Inspection of Automatic Sprinkler System

AW8 Yanfeng East London Industrial
Development Zone

UNC.8475

Photo 1

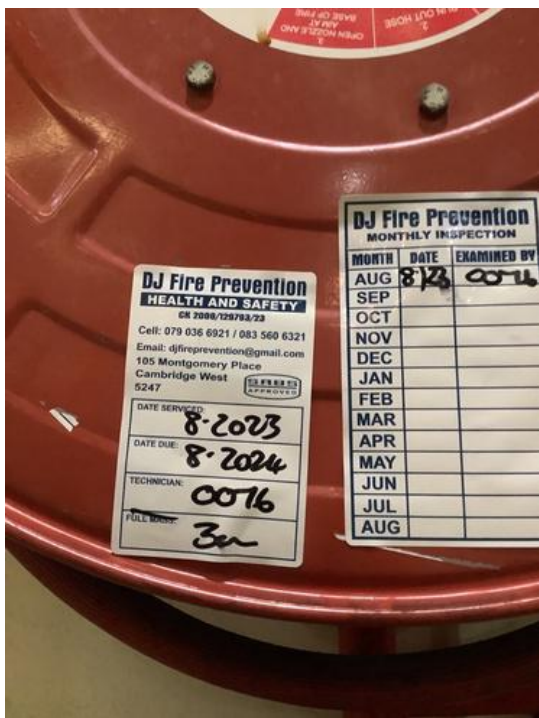
Clear access to the hand fire appliances must be maintained at all times.

Photo 14

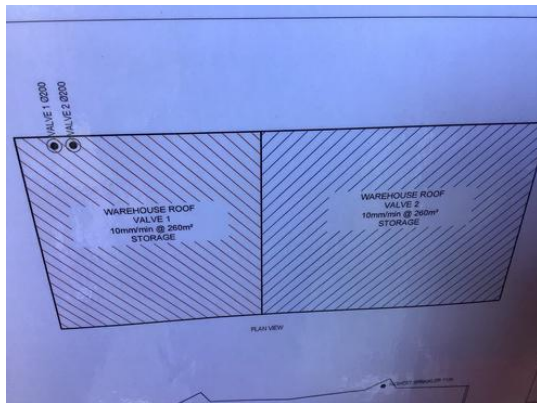
The bolts for these flanges must be removed and replaced with the correctly sized bolts so as to ensure that at least two full thread pitches past the chamfer protrude beyond the nut.

Photo 15

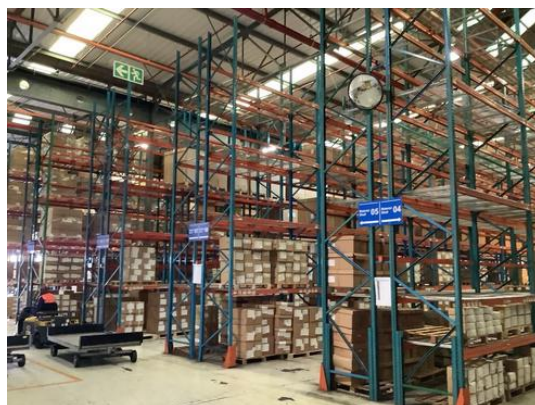
The storage heights must be maintained in accordance with the maximum allowable stack heights as detailed in this report. Should this not be possible, intermediate level protection is deemed to be mandatory.
